# **FINAL DRAINAGE PLAN**

## **SKYLINE AT LORSON RANCH**

**DECEMBER, 2021**

Design Point 39 (street runoff from the west side of the inlet)

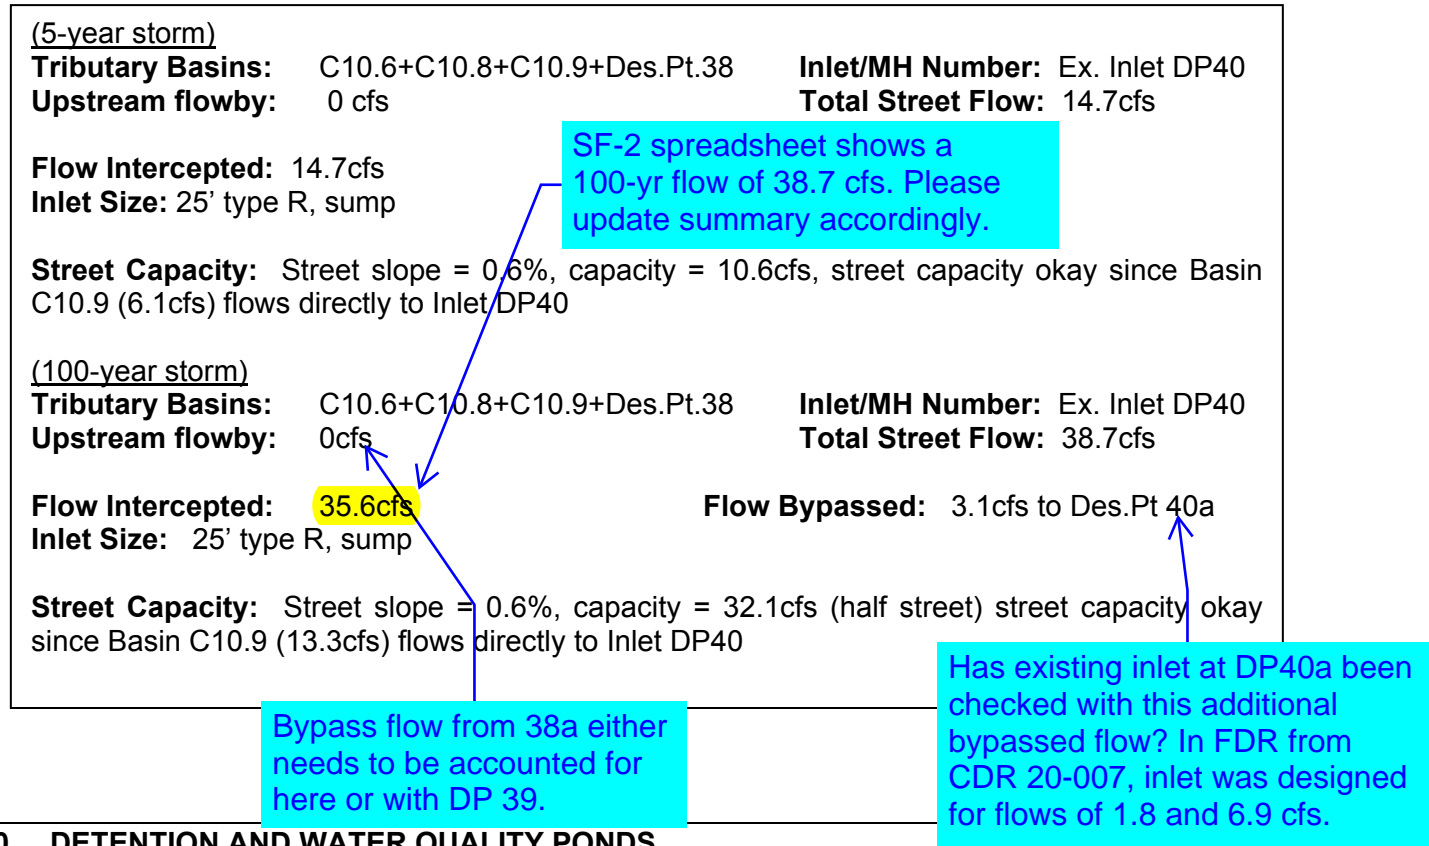
Add that DP 39 is just upstream of and prior to DP 40.

Does this DP take into account the bypass flow from DP 38a?

## Routed Hydrograph Results

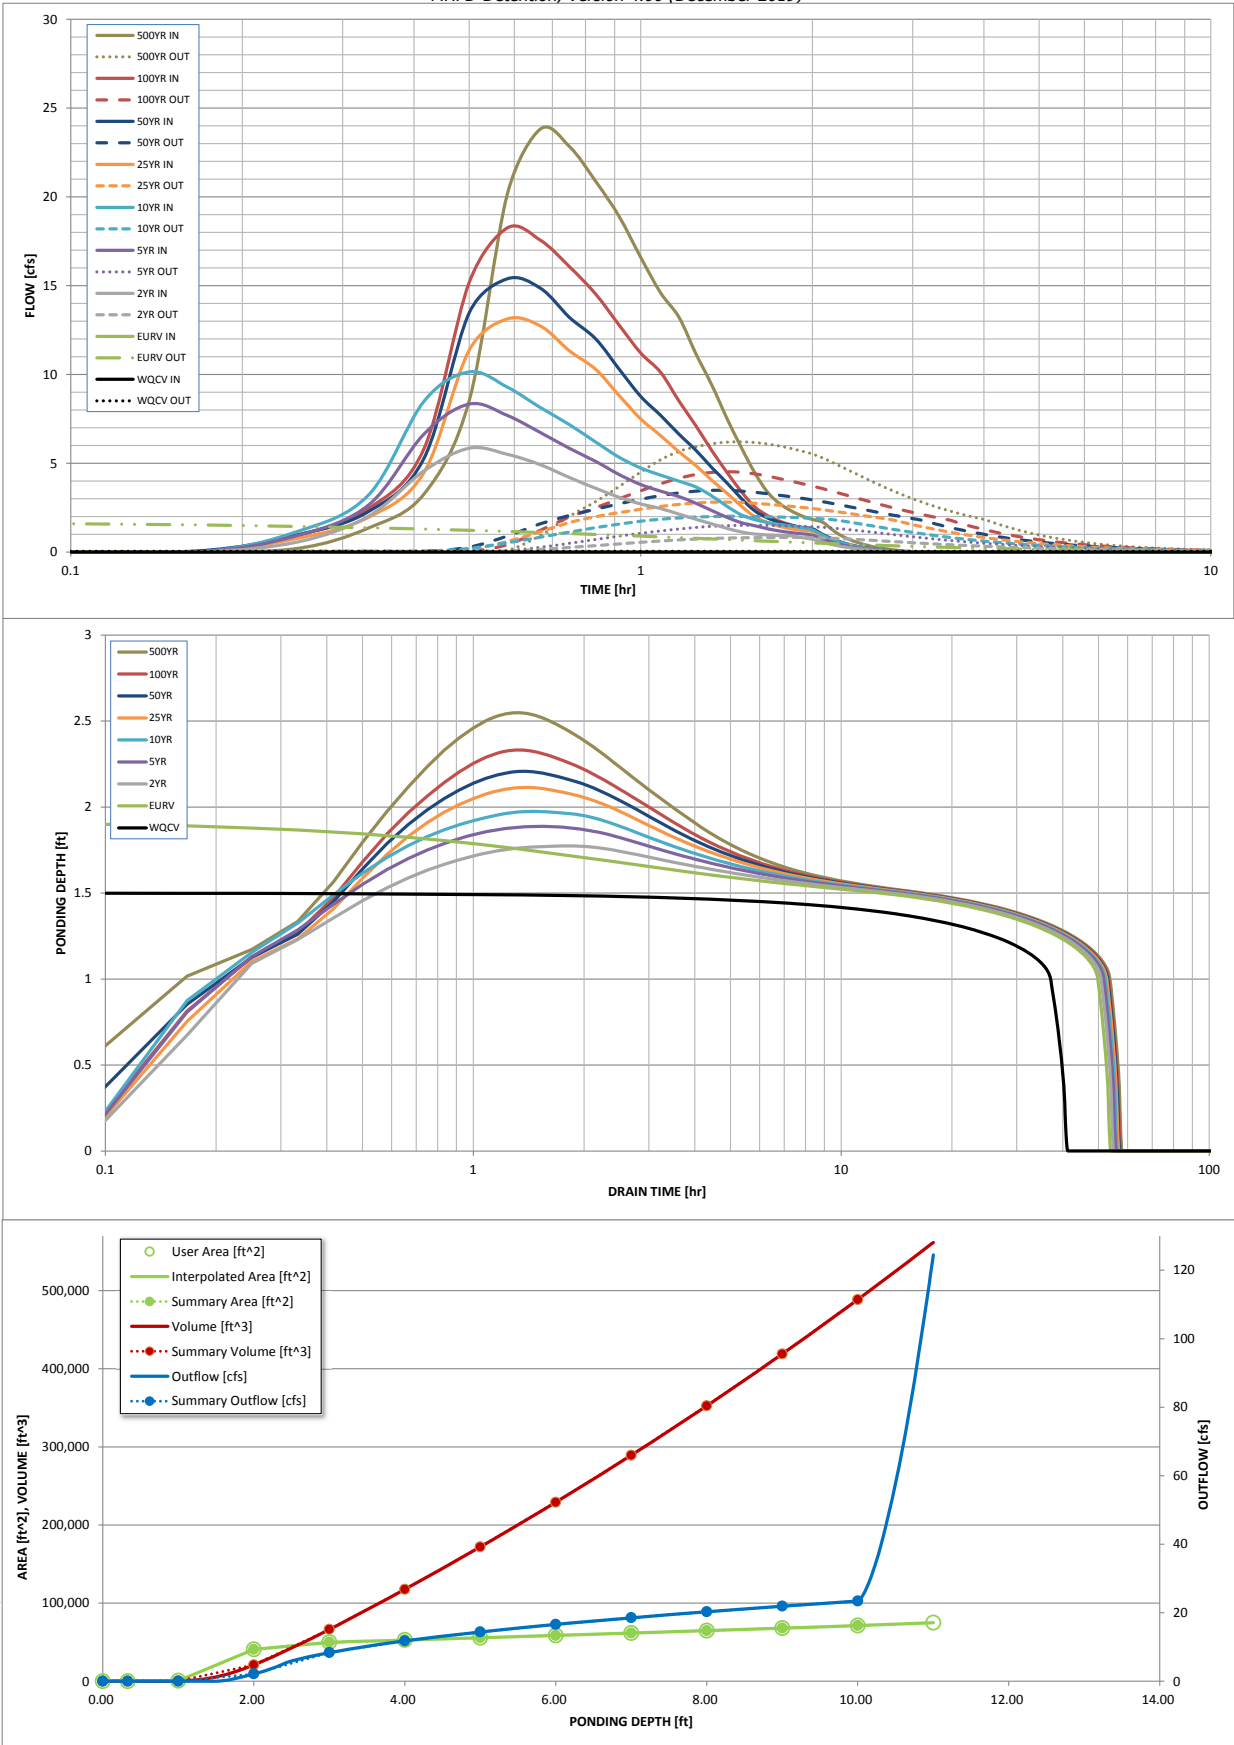
UD Detention spreadsheet "Basin" information for full buildout scenario was missing. Volumes and WS elevations could not be verified. Please include sheet next submittal.

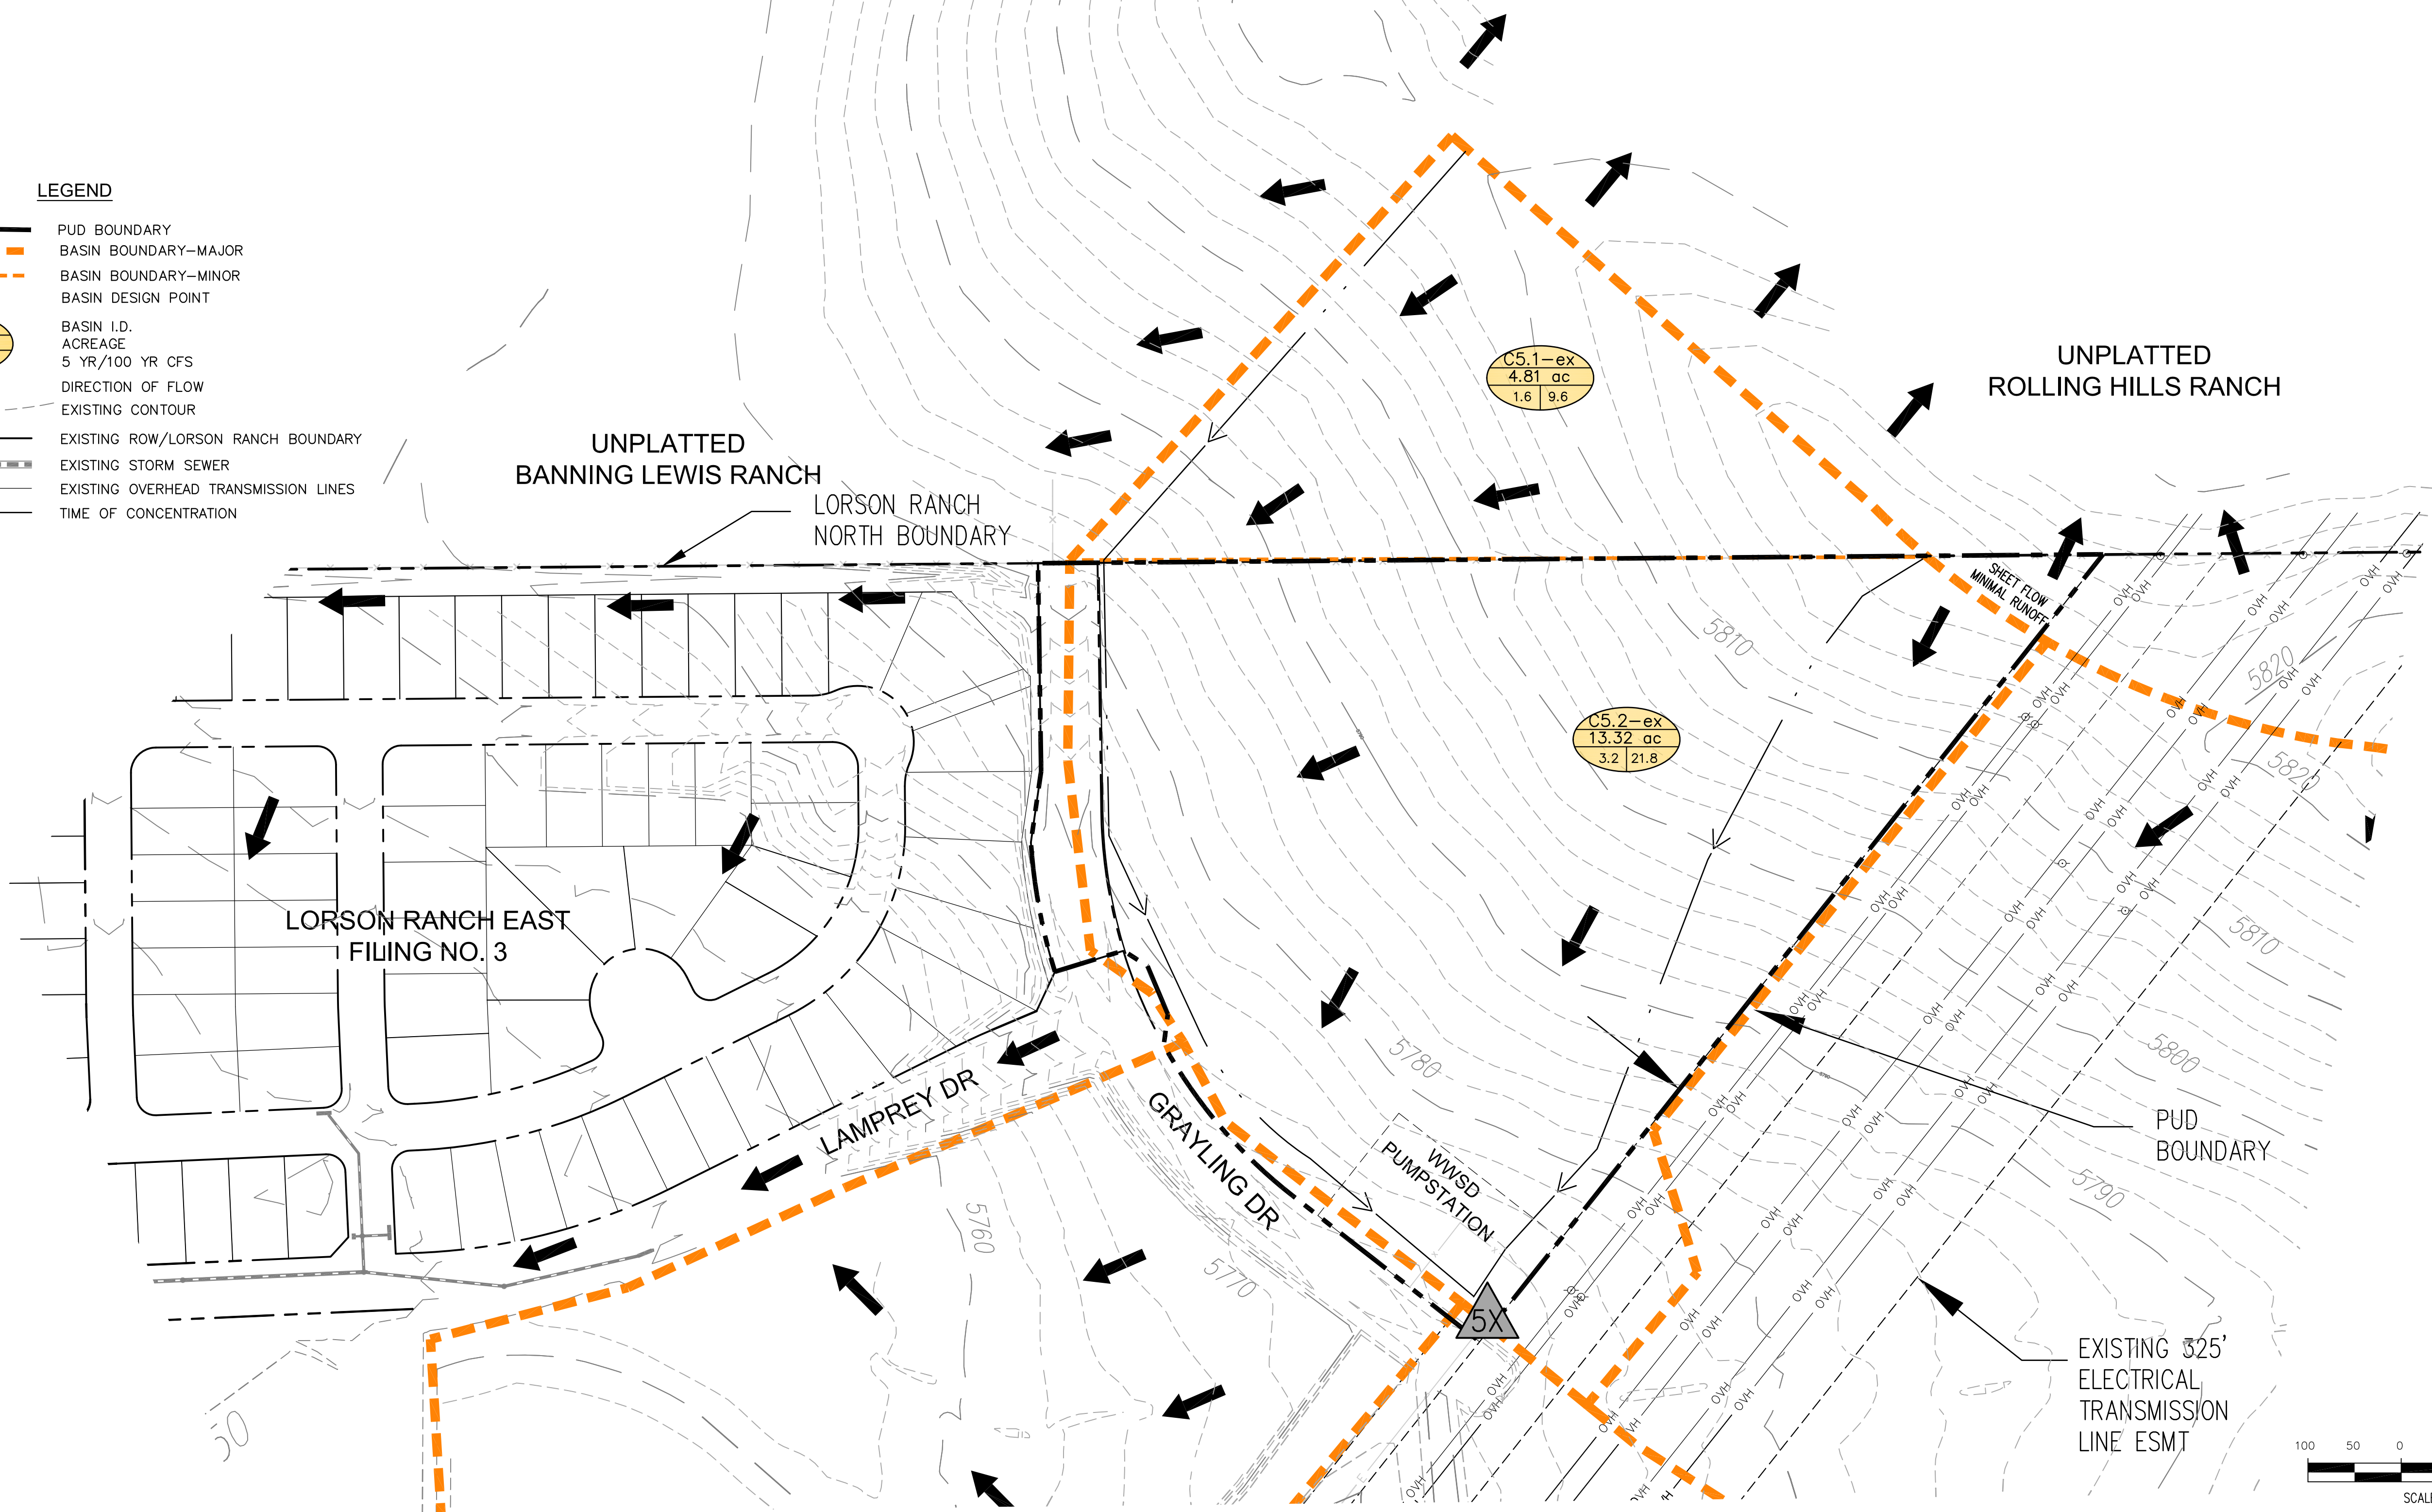
Update table per current plat status  
(Creekside South Filing 1, Hills at  
Lorson Ranch East Filing 1?)

RUNOFF SUMMARY				
D.P.	AREA (acres)	5 YEAR cfs	100 YEAR cfs	NOTES
38	7.98 ac	6.8	22.1	STREET FLOW
38a	3.75 ac	7.4	16.4	STREET FLOW
38b	5.42 ac	2.8	6.2	STREET FLOW
38c	6.96 ac	3.3	7.2	STREET FLOW
39	9.87 ac	8.5	25.1	STREET FLOW FROM NORTH
40	14.25 ac	14.7	38.7	STREET FLOW

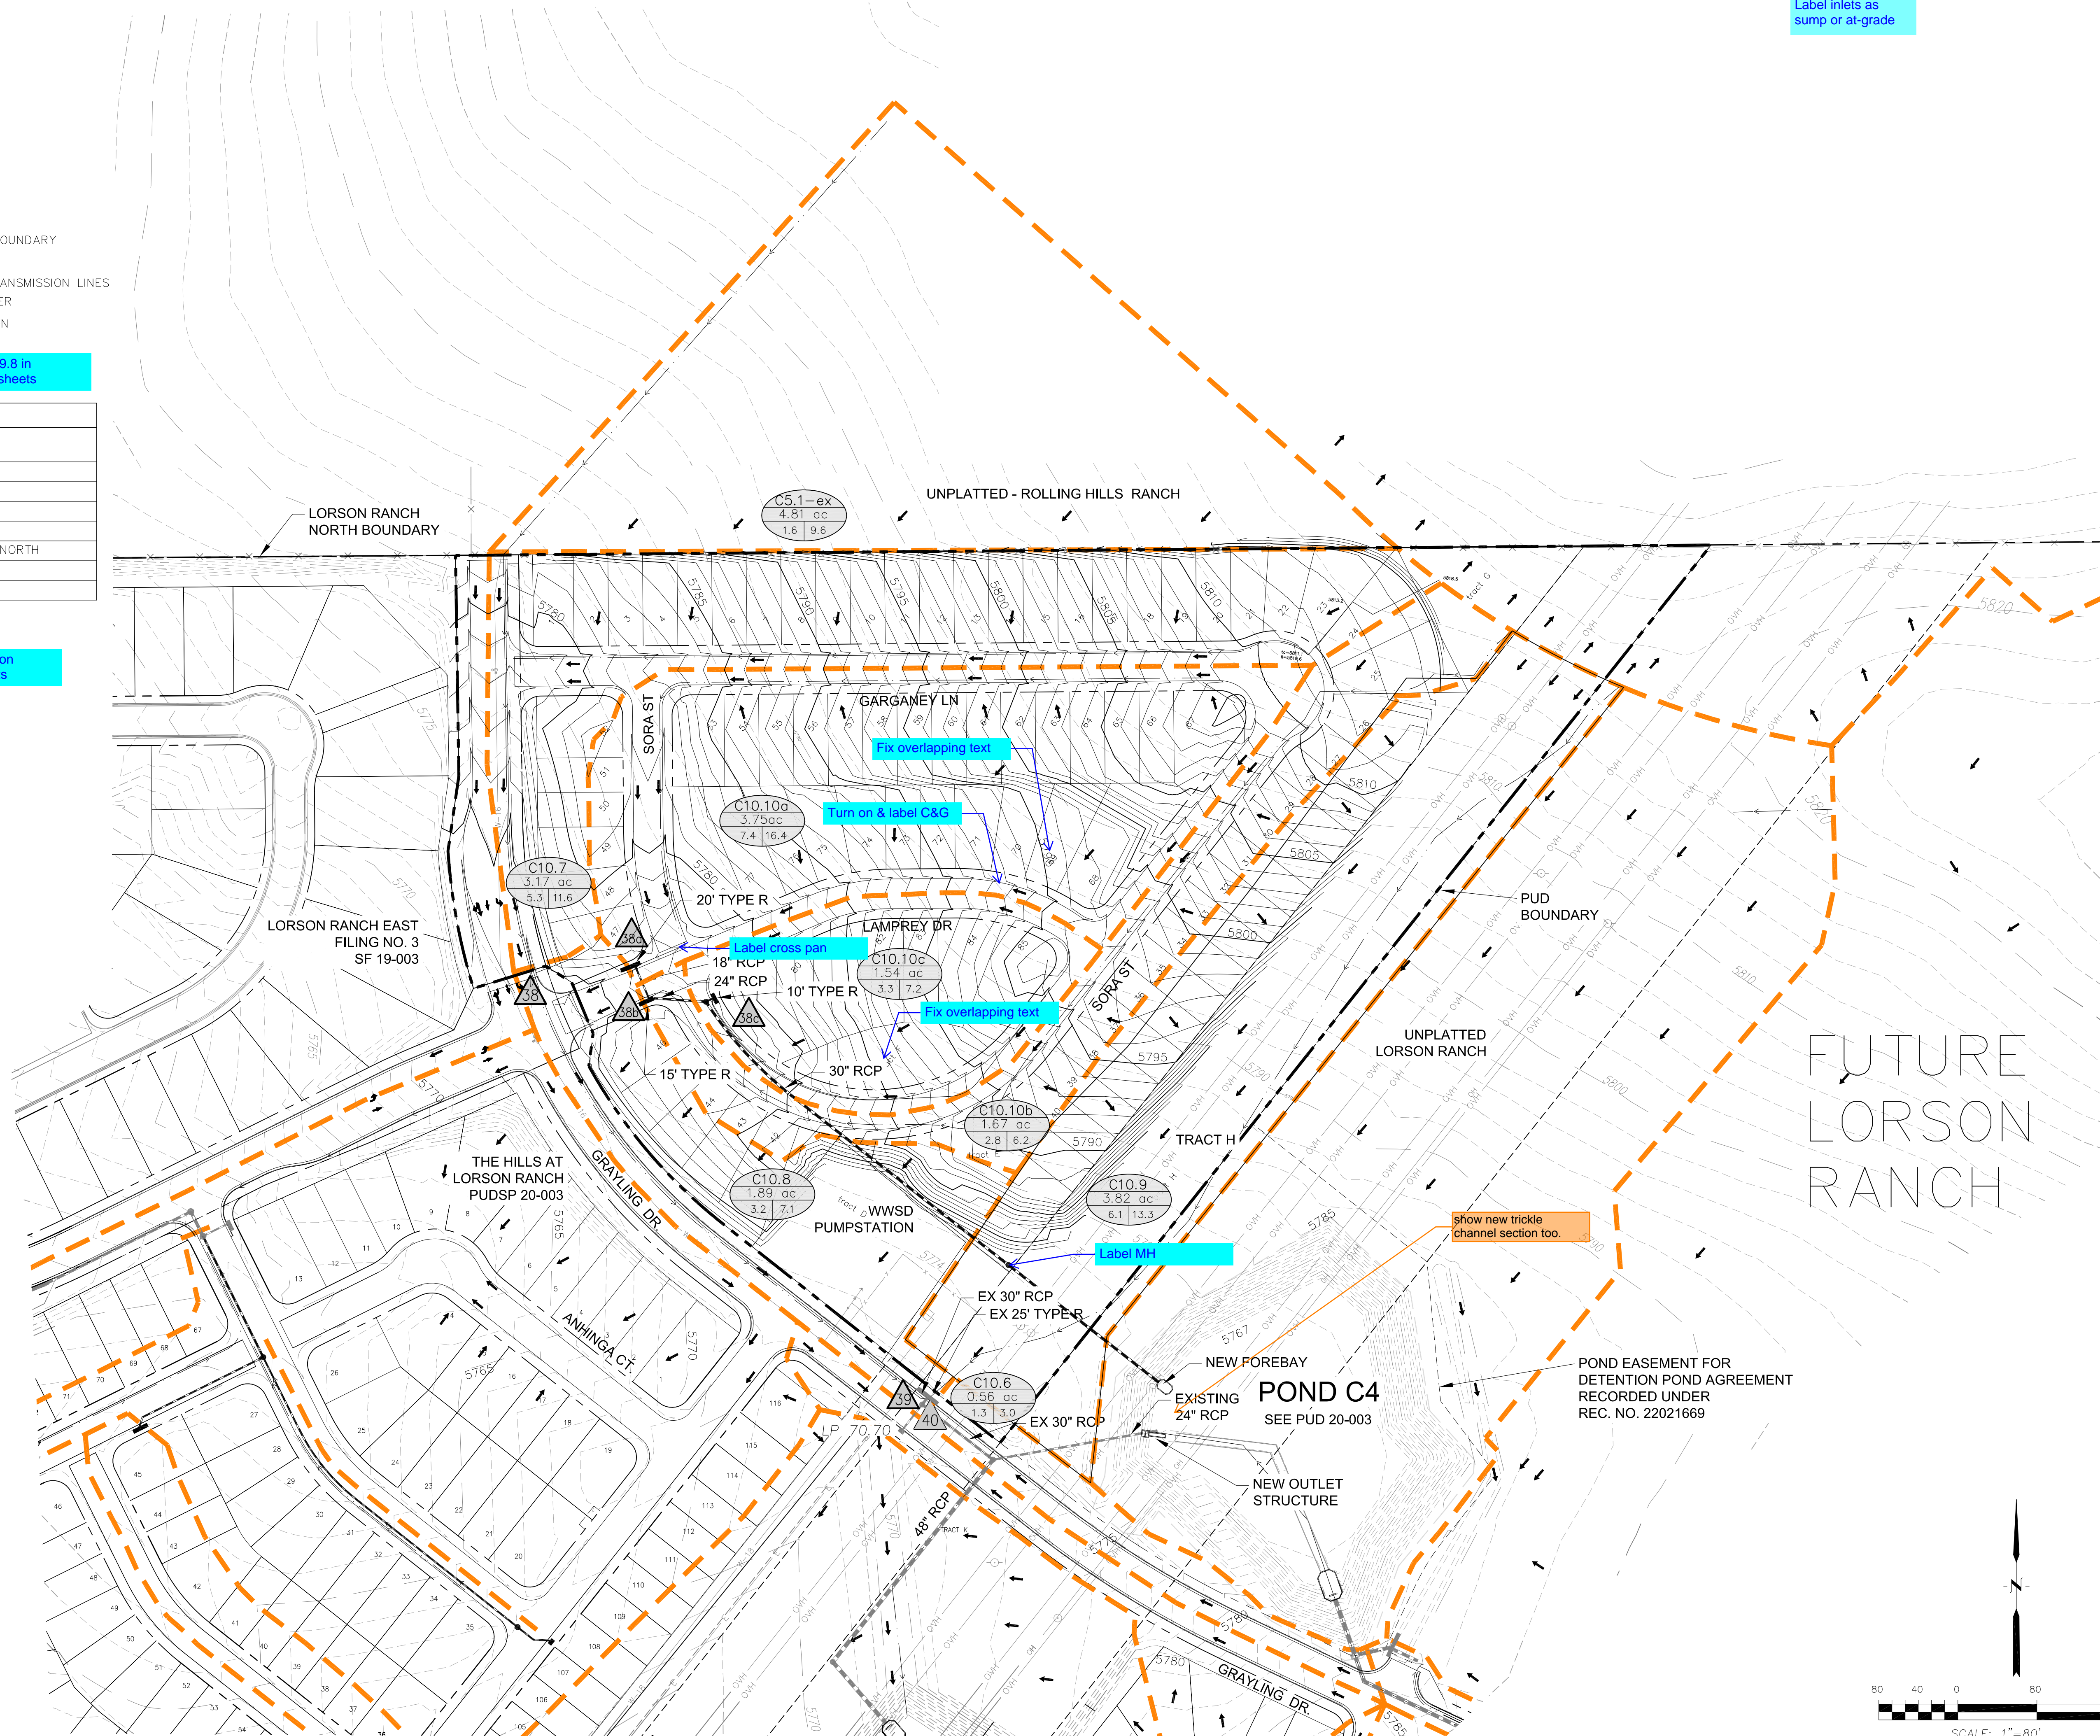
This basin is not shown on the drainage map on pg 59. From the basin description below, this basin seems to overlap with the previous 3. Please clarify/revise as needed.

Flows do not match summary table on map. Please revise accordingly so spreadsheet and map match

Flows do not match summary table on map. Please revise accordingly so spreadsheet and map match

No Basin C10.10 shown  
on map. Please delete  
information
